Access Compliance Report

Public Rights-of-Way

(Curb Ramps)

Intersection ID: 19068	Main Street: CRESTBROOK_DR	Cross Street: RANDOLPH_RD	Location:	S
ADA ID: 7F099E72D774	Ramp Type: PerpDiag	Initial Pass/Fail: Fail	Overall Compliance: No	Severity Score: 25
Codes/Mitigation Info/Possible Solution		Field Measurements/Component Compliance

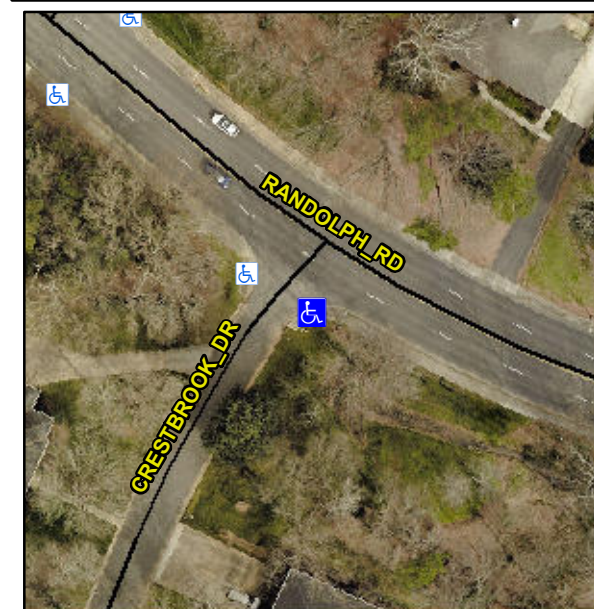
Not Found, R304.5.3

Compliance	Description	Data	Compliance	Description	Data
N/A	Ramp Length (in)	58.0	Yes	Ramp Slope (%)	5.5
Yes	Ramp Width (in)	48.0	No	Ramp XSlope (%)	7.5
N/A	Flare Type LT	N/A	N/A	Flare Type RT	N/A
N/A	Flare Slope LT (%)	N/A	N/A	Flare Slope RT (%)	N/A
N/A	Flare Traversable LT?	N/A	N/A	Flare Traversable RT?	N/A
N/A	Landing Length (in)	N/A	N/A	DWS Provided?	N/A
N/A	Landing Width (in)	N/A	N/A	DWS Contrast?	N/A
N/A	Landing Slope (%)	N/A	N/A	DWS Length (in)	N/A
N/A	Landing X Slope (%)	N/A	N/A	DWS Full Width?	N/A
N/A	Landing Curb? (Y/N)	N/A	N/A	DWS Offset (in)	N/A
N/A	Shared Landing?	N/A			
N/A	Gutter Ponding?	N/A	N/A	Gutter Slope (%)	N/A
N/A	Gutter Lip Ht (in)	N/A	N/A	Gutter X Slope (%)	N/A
N/A	Painted X Walk1?	No	N/A	Painted X Walk2?	No
	X Walk 1 Direction	To NE		X Walk 2 Direction	To NW
N/A	X Walk 1 Width (in)	N/A	N/A	X Walk 2 Width (in)	N/A
	X Walk 1 Slope (%)	2.4		X Walk 2 Slope (%)	4.1
	X Walk 1 X Slope (%)	3.4		X Walk 2 X Slope (%)	5.2

Remove & Replace Curb Ramp With Two New Directional Ramps or Equivalent.
